SERVICE MANUAL

Xone:92 Service Information

XONE:92 - Historical Change Log

XONE:92 Filter 1 & Filter 2 PCB modification

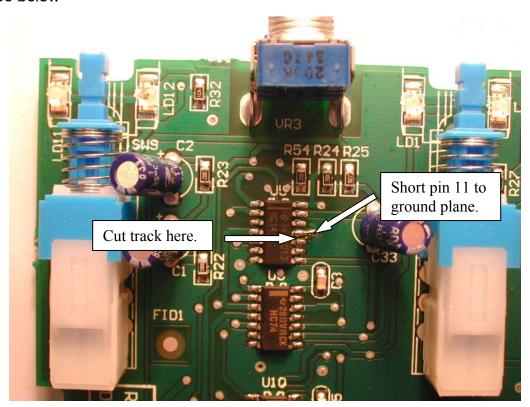
ECN No: 984

Assembly No(s): 003-138 & 003-143, iss.2

Reason: EMC emission reduction

Assy 003-138 & 003-143, PCB AG5300 issue 2 See below

This modification was carried out on issue 2 PCBs from March 11th 2004 until the introduction of the issue 3 PCBs.
